Avolites Ltd. Engineering Change Notice

Title	Rack Splitter DMX Termination modifications.
ECN Number	ECN-0113
Equipment	IOA 3200A pcb
Author	Alwyn Fernandes
Drawing Number	
Date	7 th December 1999

Track Side View

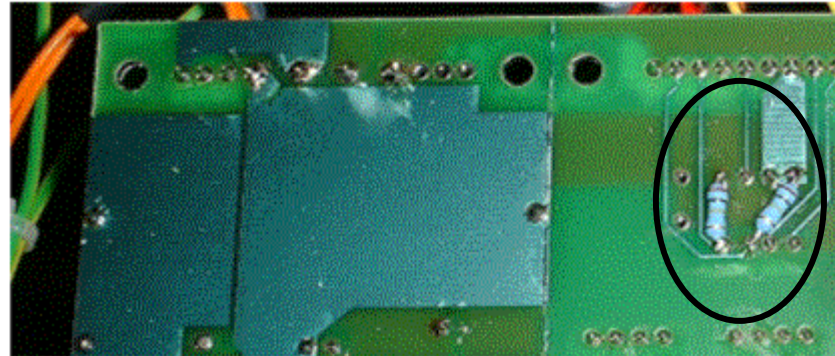
Reason for ECN	Stop data leds coming on when no DMX cable is present.
Special Parts required	Two 100K resistors and twp strips of dimmer tape
Special Tools required	Soldering iron

Two termination resistors (100K) have to be fitted to the track side of IC201 (SN75178). These two resistors are fitted across pins 1&8 and pins 4&7
